Company	Trenz Electronic GmbH
PCN Number	PCN-20211014
Title	TE0802-02 LPDDR4 Change and Product Update
Subject	BOM change
Issue Date	2021-11-05

This change affects Trenz Electronic TE0802 boards of revision 02: TE0802-02

2.5 #5 S/N not assembled

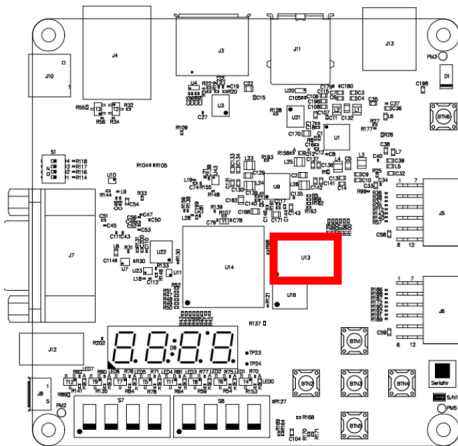
Type: BOM change

Reason: Part is end of life.

Impact: Track it pad no more available.
